**Subject: 576 Riverside Drive
Replacement Wastewater Disposal System
Augusta, Maine**

Subject: Approval, Cooper Properties, Inc. Property, 576 Riverside Drive, Augusta

PROJECT
576 RIVERSIDE DRIVE
SUBSURFACE WASTEWATER SYSTEM
 TITLE
REVISED SITE PLAN

EXHIBIT A

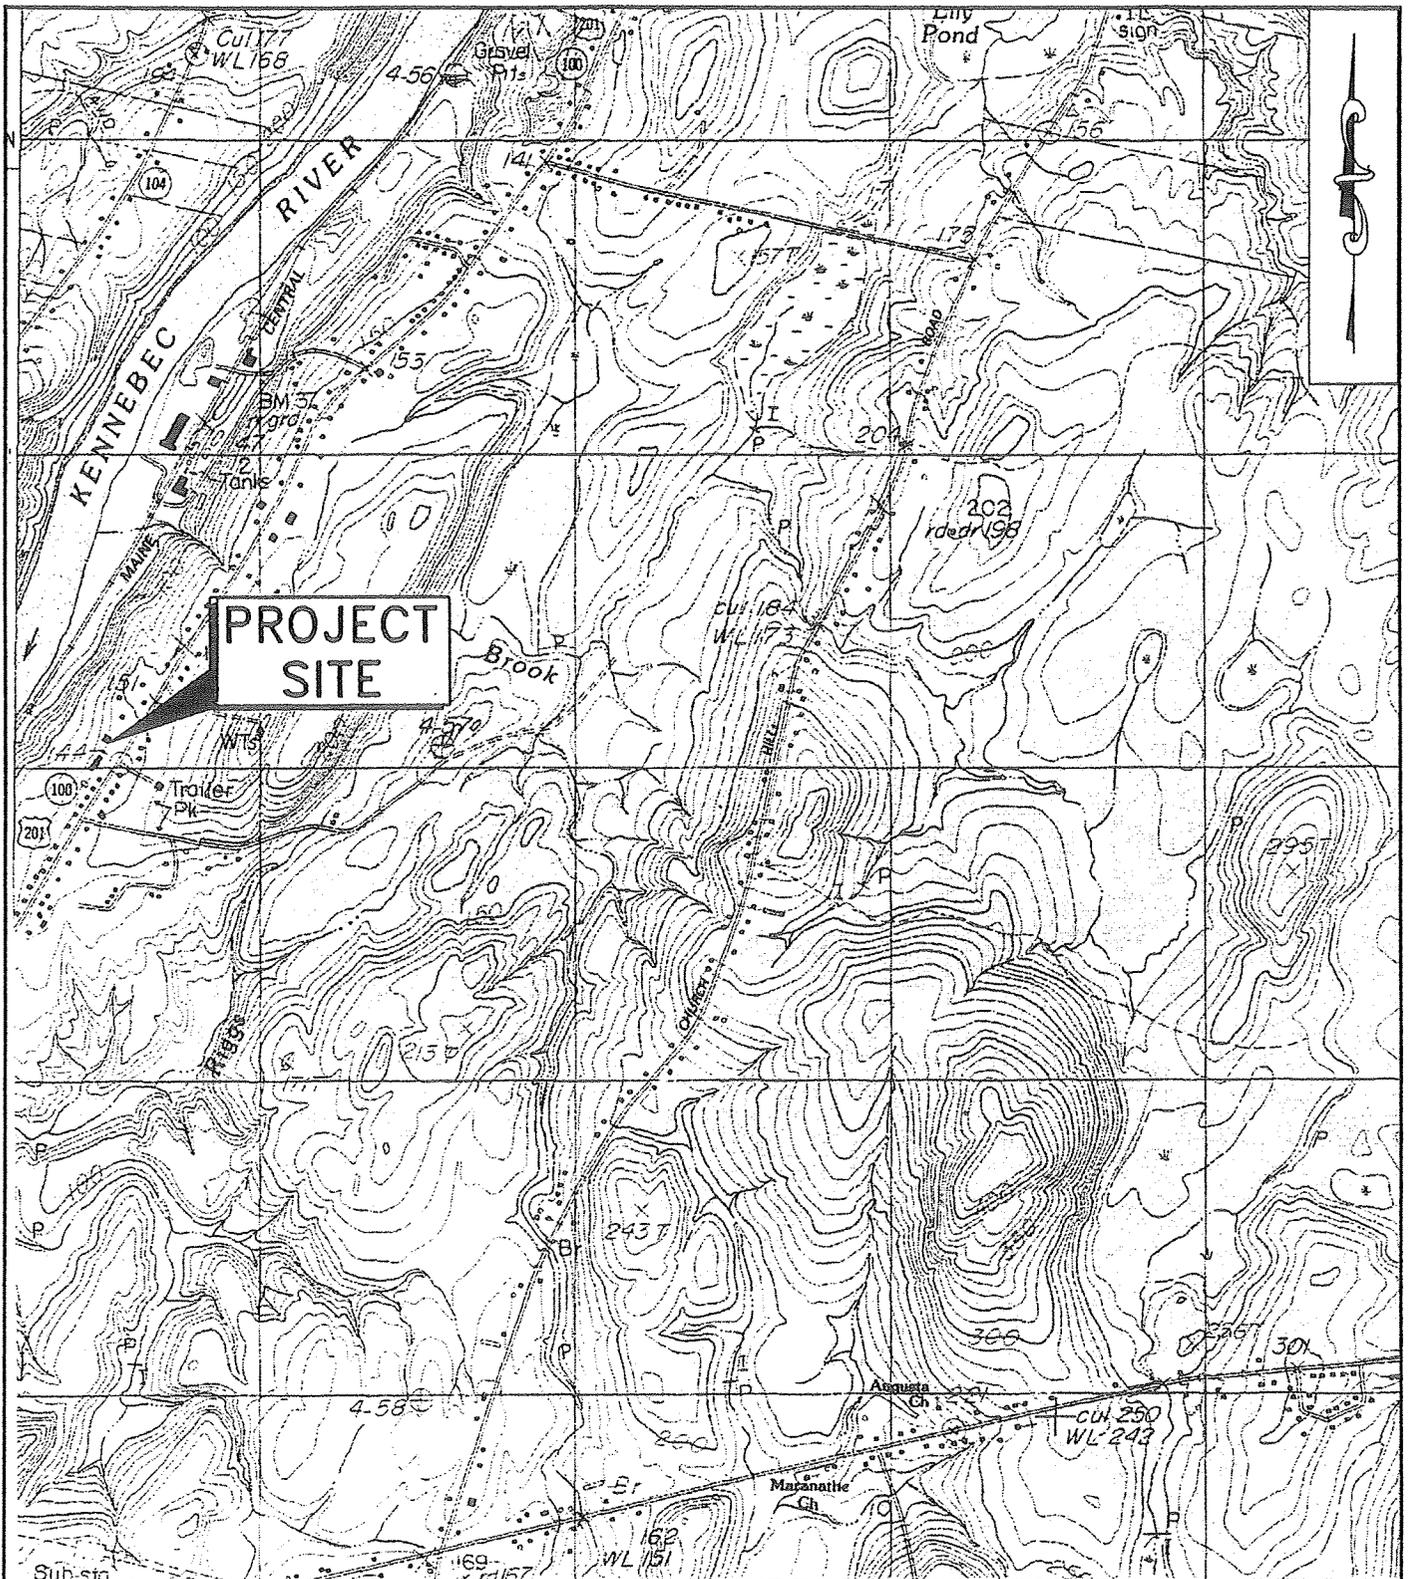
MDEP also provided the following specific comments: the 68.5 gpd/ft.² hydraulic conductivity (K) value used in the mounding analysis appears inappropriate, and ought to be in a range between 9.0 gpd/ft.² - 30 gpd/ft.² pursuant to N.R.C.S. values for Nicholville soils; and the site location is shown incorrectly on the USGS topographic map supplied.

The remaining conditions, 2 through 15, will be complied with as the project moves forward. Additionally, we have included revised and corrected copies of Exhibits A and E.

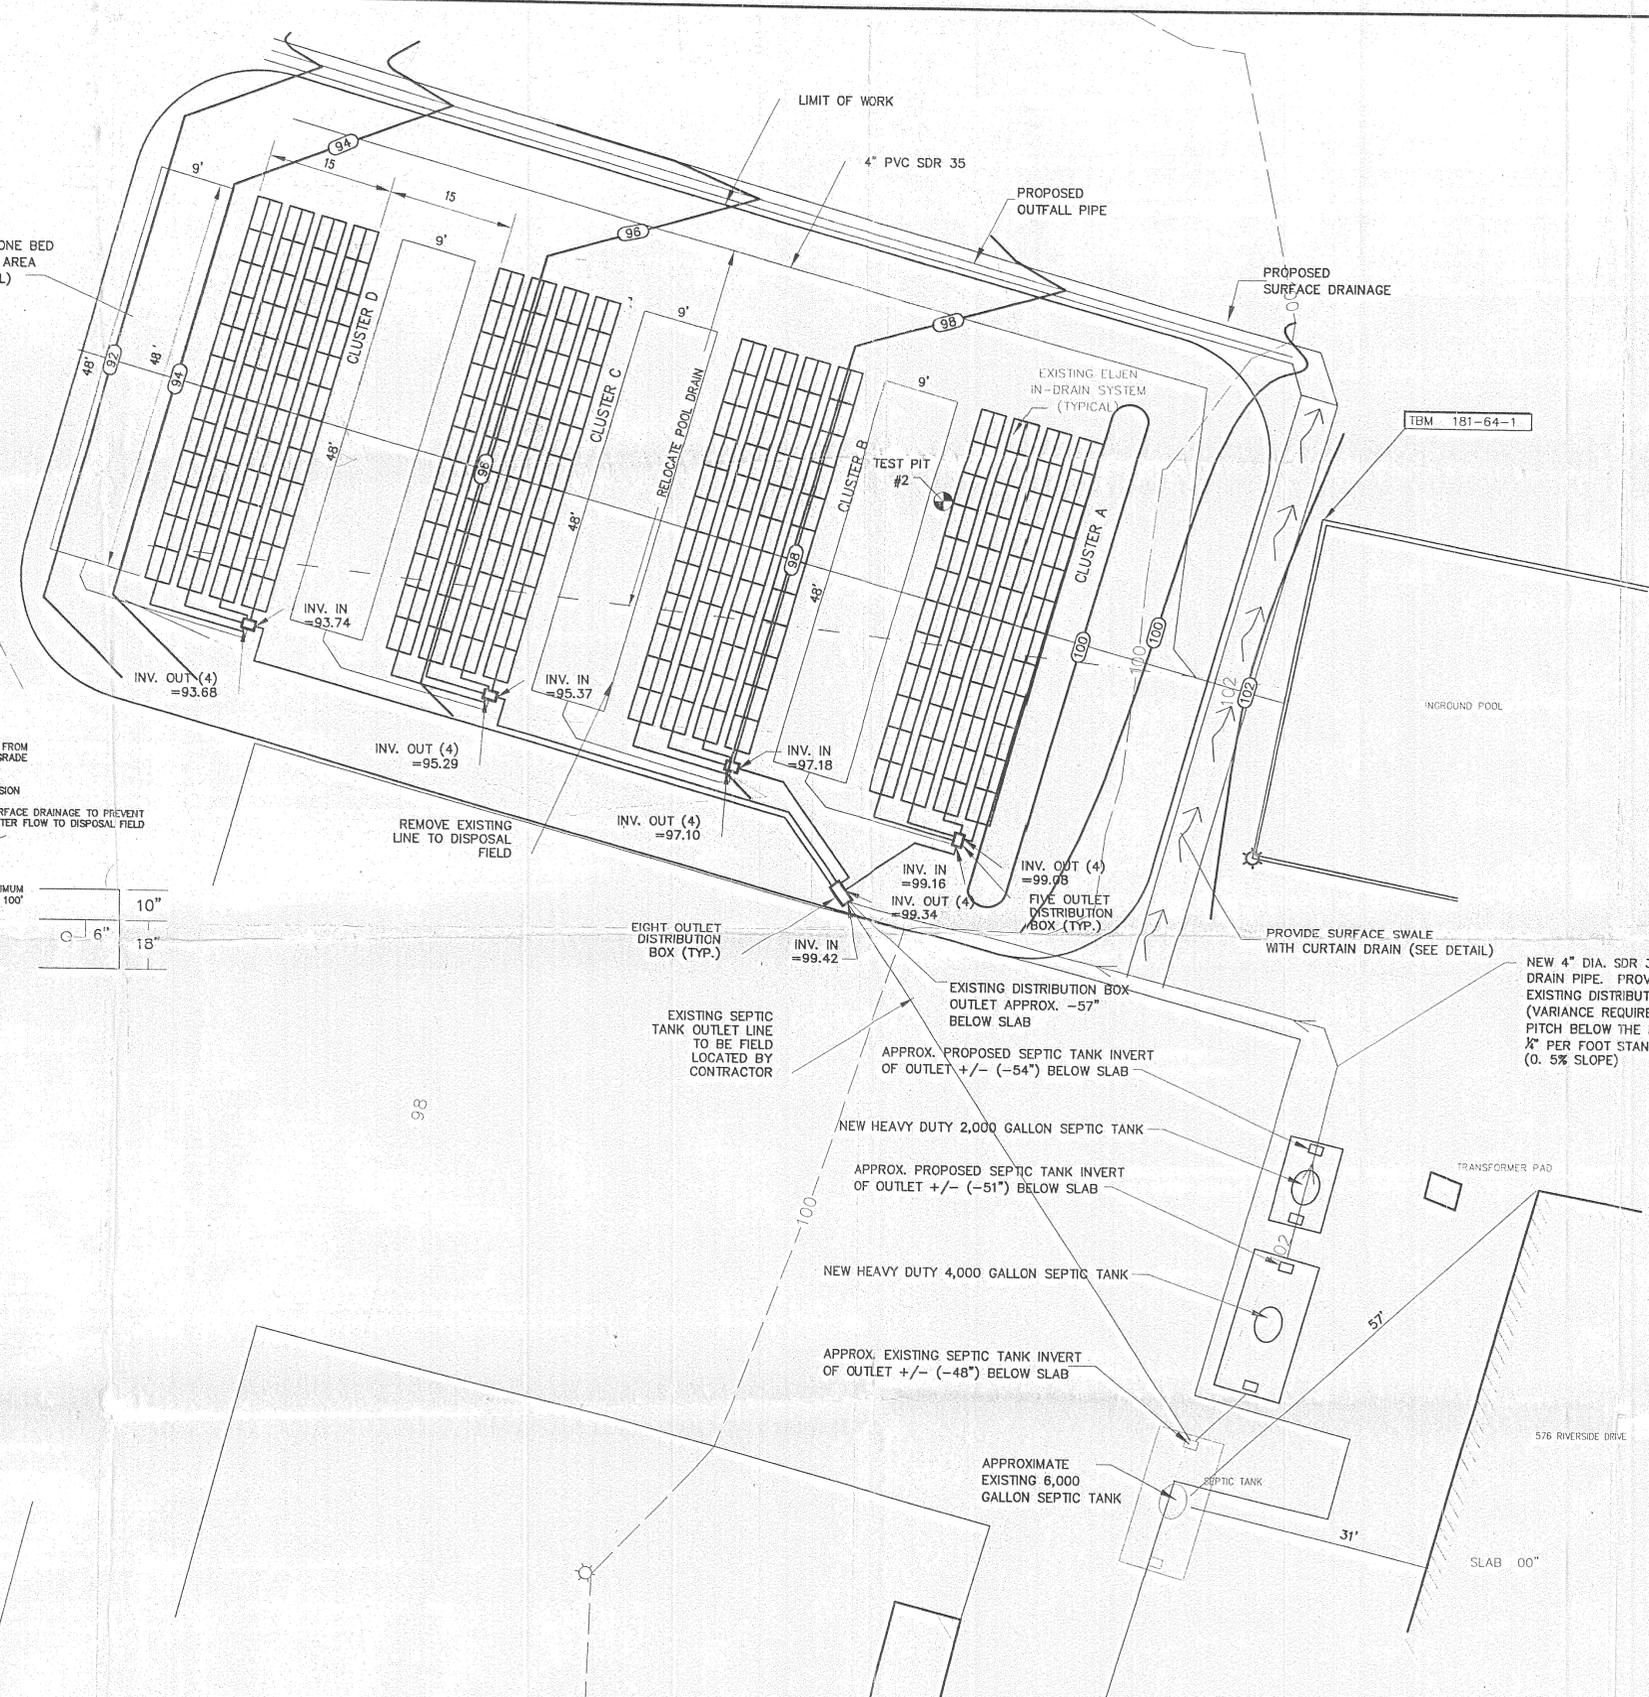
The plan lacks contour lines pursuant to Section 1102.6 of the Rules.

1. Prior to issuance of a permit by the Local Plumbing Inspector to install the proposed expansion, the design engineer shall:
 - A. Submit to the Division for review and approval a revised site plan with contour lines, and
 - B. Submit to the Division for review and approval either a revised site plan showing one additional 2,000 gallon septic tank and one additional 4,000 gallon septic tank; or a revised narrative description which includes one additional 6,000 gallon septic tank. The number of existing tanks shall also be verified, and
 - C. Submit to the Division for review and approval a revised page 1 of the HHE-200 Form with latitude and longitude conforming to Section 401.6.1 of the Rules, and

- 1.A. The revised site plan with contour lines.
- 1.B. The goal of adding additional septic tanks is to result in a total in-place volume of 12,000 gallons. The goal will be achieved by:
 - Existing built in place tank 6,000 gal.
 - First new commercial tank 4,000 gal.
 - Second new commercial tank 2,000 gal.

REV	DATE	STATUS	BY	CHKD	APPD
1	2-9-07	PROPOSED CONTOURS ADDED	ARA	CJM	SCD
